**\*\*\*AGENDA\*\*\***  
**HISTORIC CONSERVATION BOARD**  
**Monday, February 22, 2016 – 3:00 pm**  
**PUBLIC CONFERENCE ROOM**  
**II CENTENNIAL PLAZA – 5TH FLOOR**  
**805 CENTRAL AVENUE**

**APPLICATION FOR  
CERTIFICATE OF APPROPRIATENESS  
AND ZONING VARIANCE  
HISTORIC CONSERVATION BOARD PUBLIC HEARING  
STAFF REPORT**

APPLICATION #: N/A  
APPLICANT: Joe Bodkin, Newbar Design Group  
OWNER: Queen City Station, LLC  
ADDRESS: 222 W. 12<sup>th</sup> Street, Cincinnati OH 45202  
PARCELS: 081-0003-0076-00  
ZONING: Commercial Community-Auto Oriented (CC-A)  
OVERLAYS: Over-the-Rhine Historic District  
COMMUNITY: Over the Rhine  
REPORT DATE: February 10, 2016  
HEARING DATE: February 9, 2016 at 2:00 p.m.  
STAFF REVIEW: Angie Strunc, City Interim Urban Conservator

**A001**

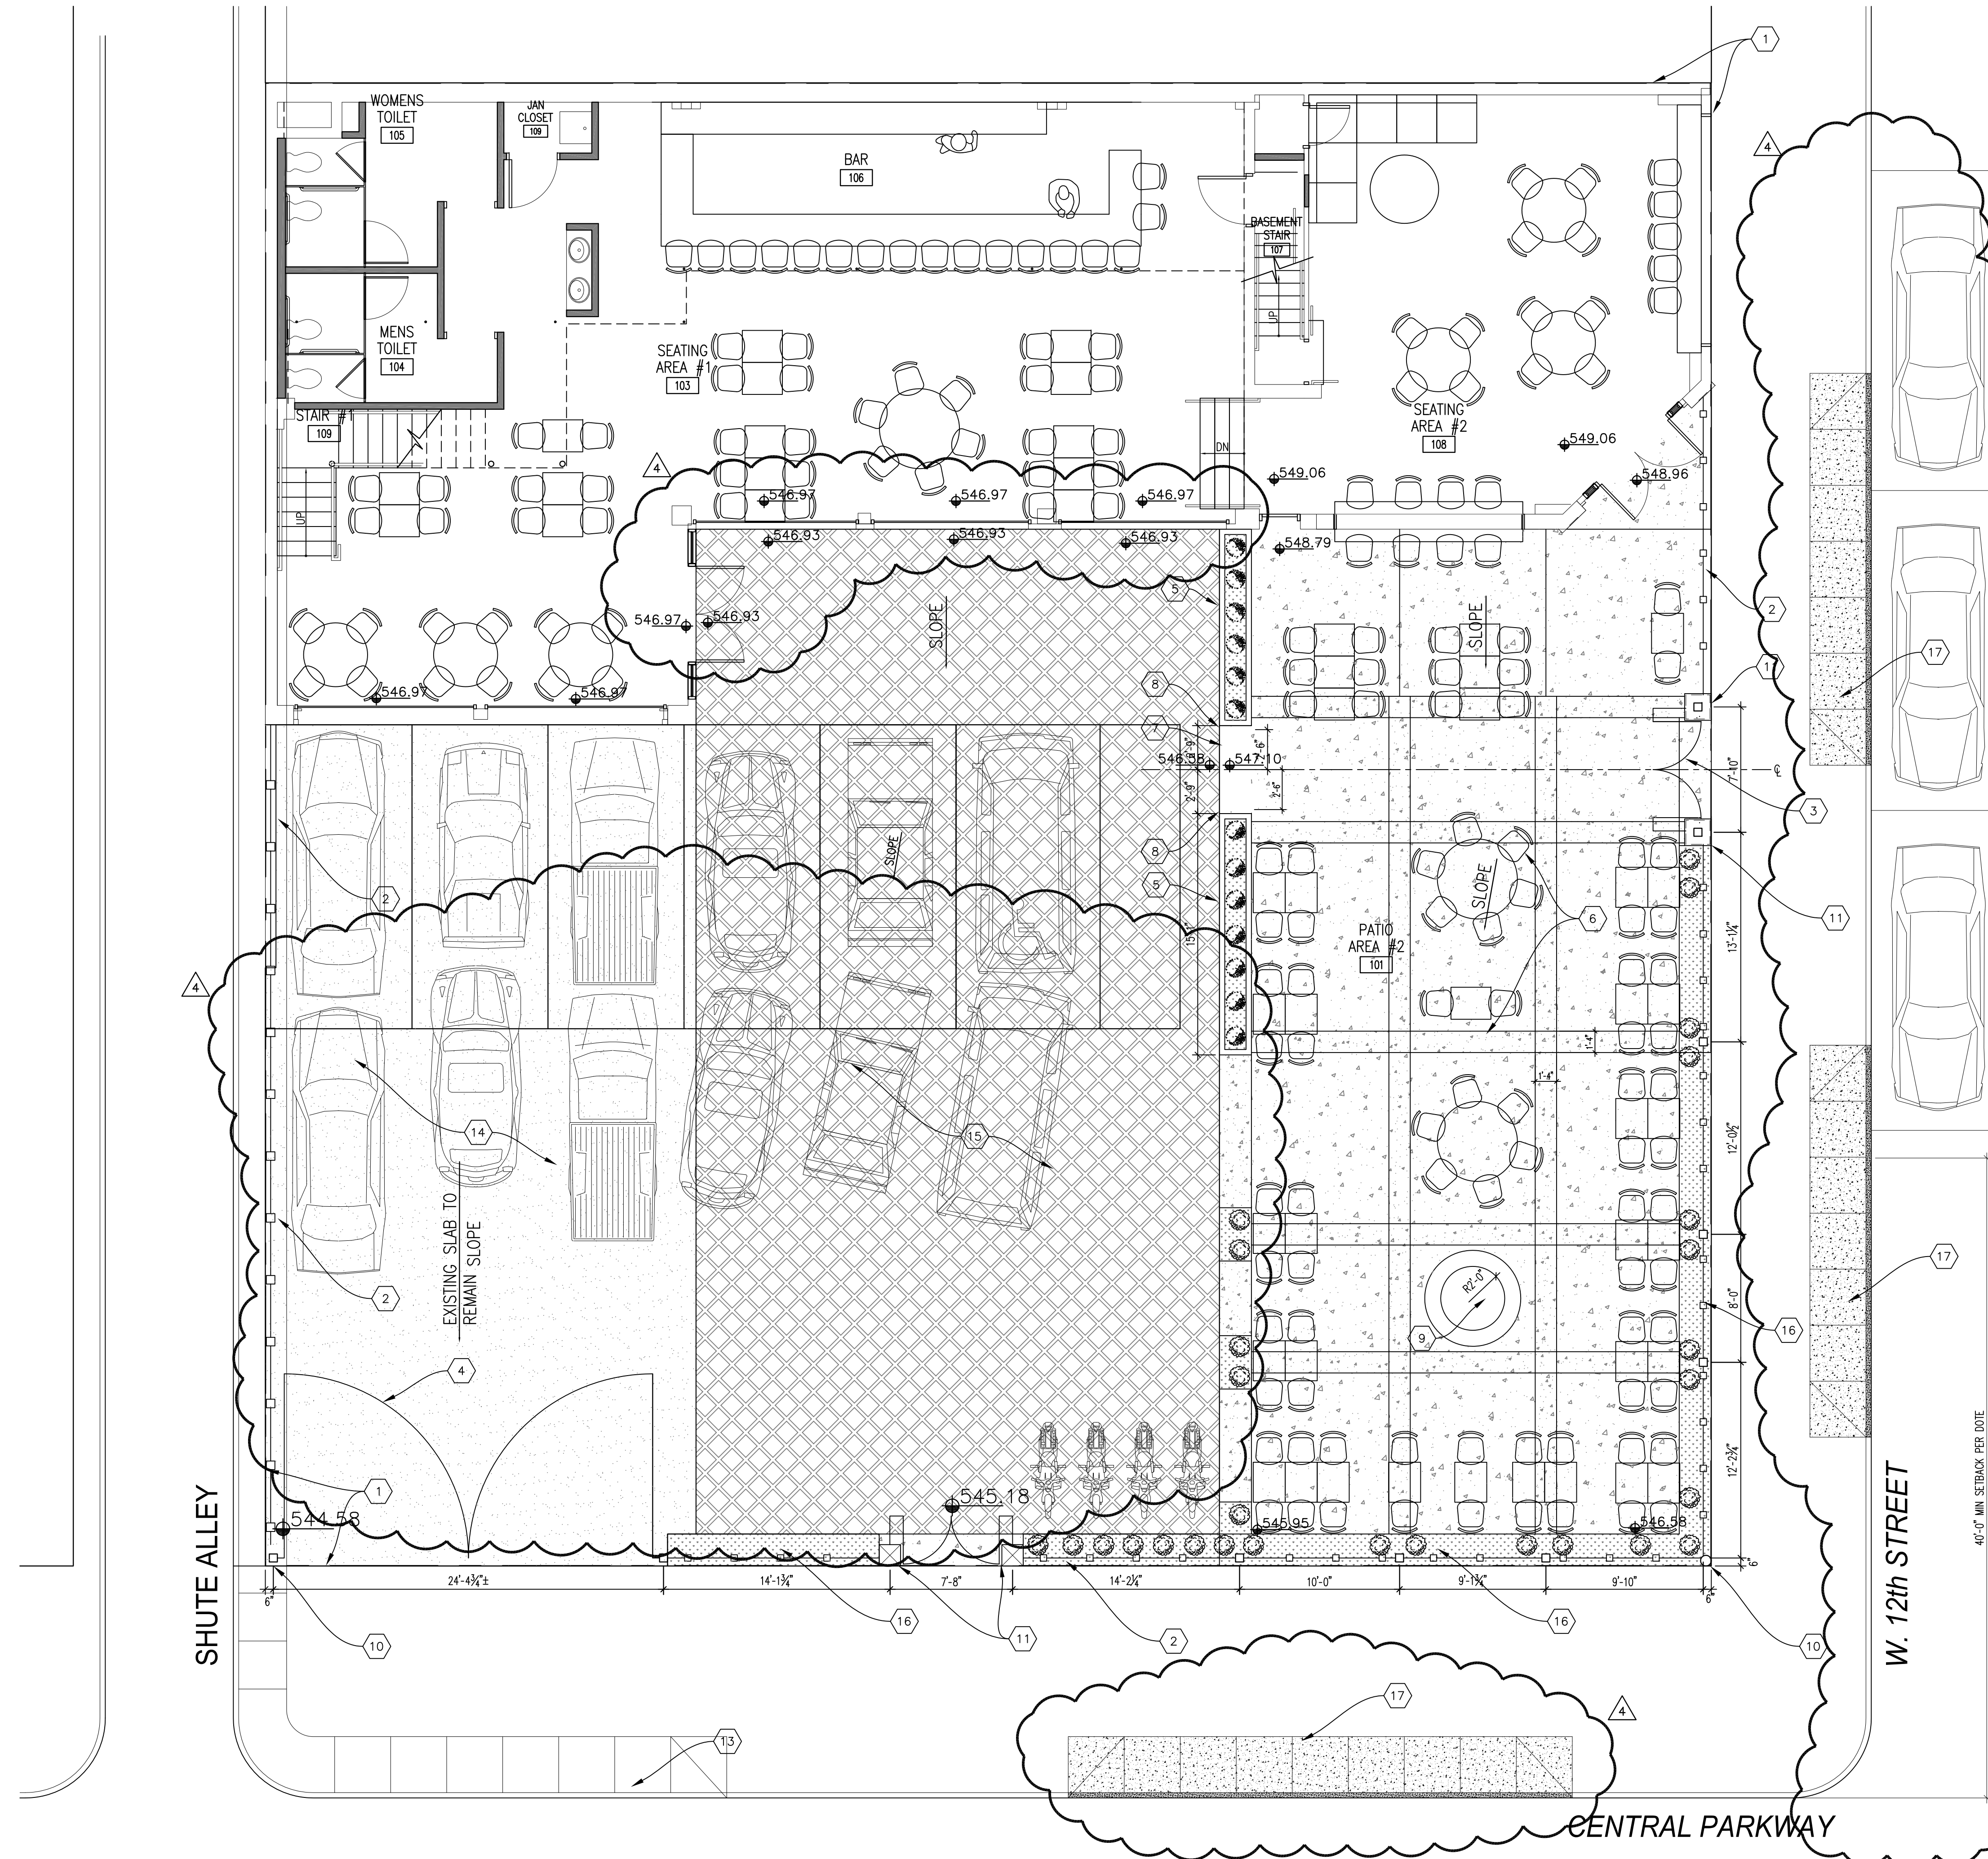
The three curb cuts that are no longer usable by traffic to access parking area must be removed and full height curb and sidewalk must be constructed. Add this to the site plan.

Add dimensions on the parking spaces and vehicle travel lane in the parking lot.

**X2.2**

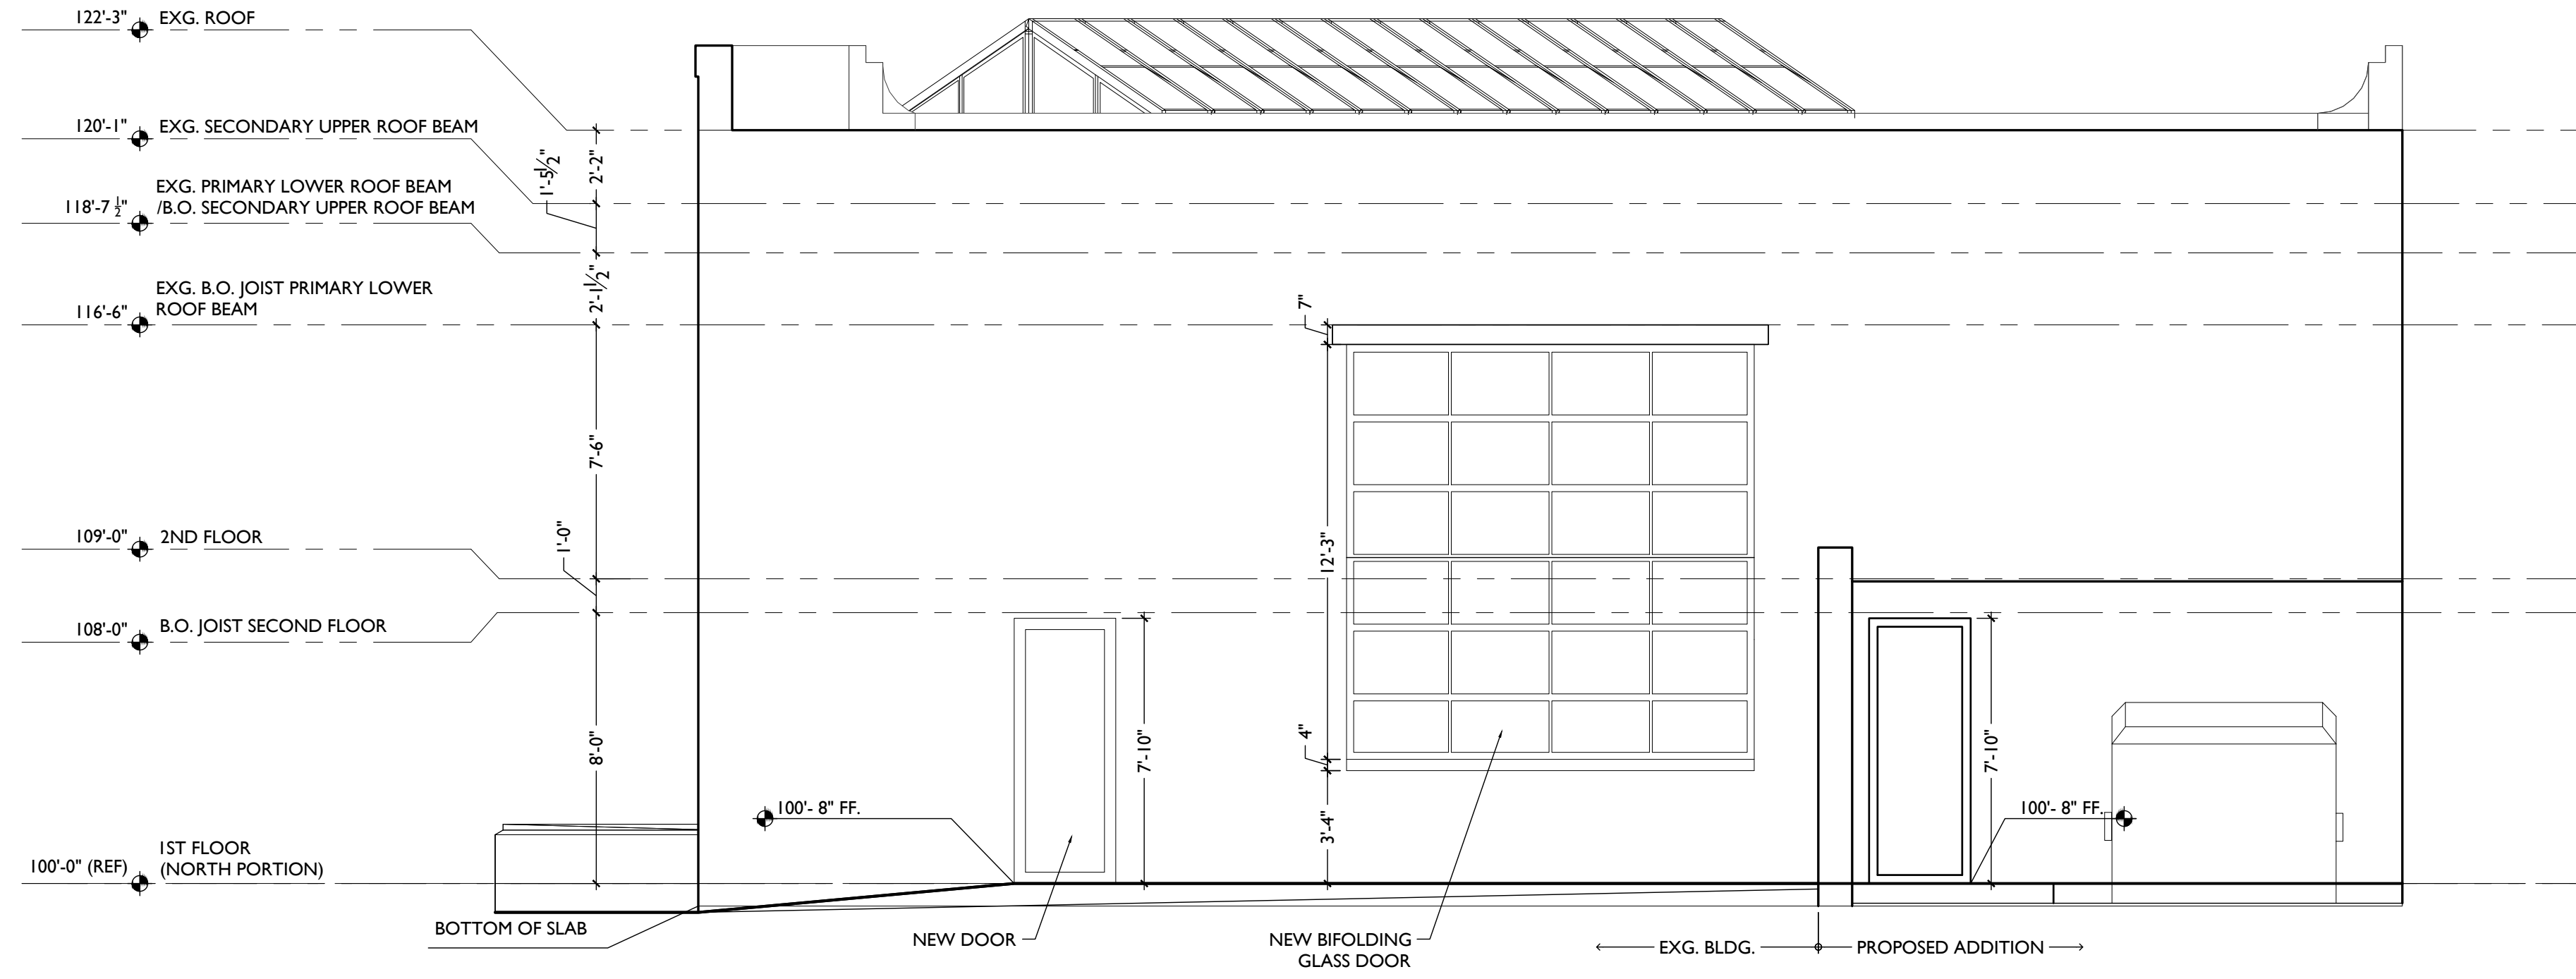
Staff recommends the new bi-fold garage opening on existing west elevation (Sheet A2.2) be lowered to finished grade elevation in lieu of the proposed 3'-4" sill height.
